## **Plan Change 1B - Hearings Report**

Prepared for  
Wairoa District Council

# Hearing Report : Plan Change No 1B Coastal Protection (Mahia)

The Plan submitted with the submission is shown below.

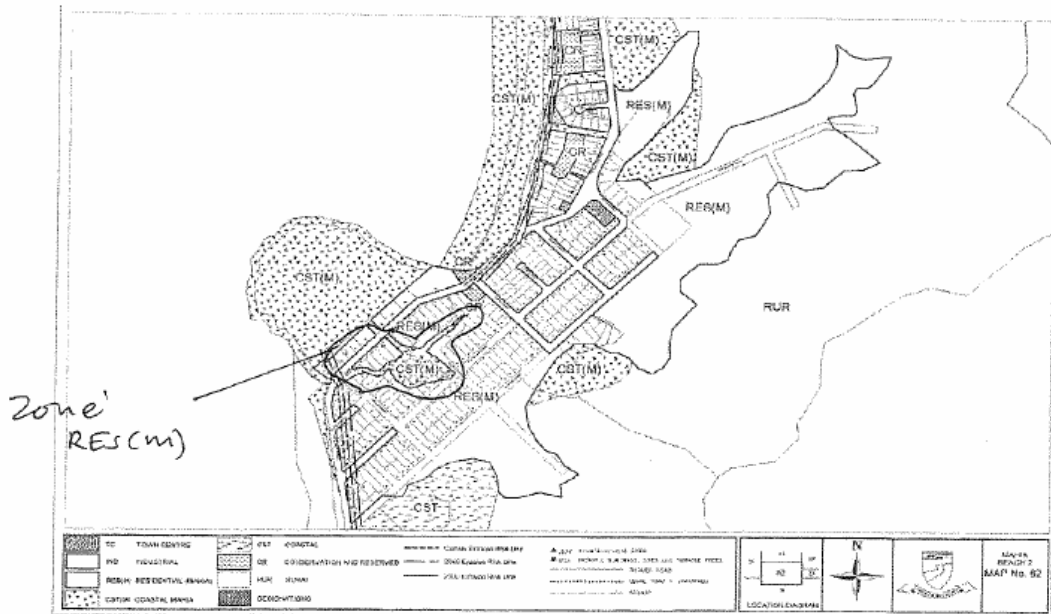
Submissions 34.1 and 51.1 oppose zoning an area of land on Planning Map 62, Mahia Beach 2 as Coastal (Mahia) Zone. The submissions state that the proposed Plan Change(s):

- “(i) Do not provide a logical zoning for the land in question*
- (ii) Result in land suited for residential growth being sterilised*
- (iii) Are not necessary to achieve the objectives and policies of the Resource Management Act, 1991*
- (iv) Are not necessary to achieve the objectives and policies of the Wairoa District Plan*
- (v) Will result in an unnecessarily fragmented approach to land management in the Wairoa District*
- (vi) The amendment to re-zoning as submitted will promote the sustainable management of natural and physical resources”.*
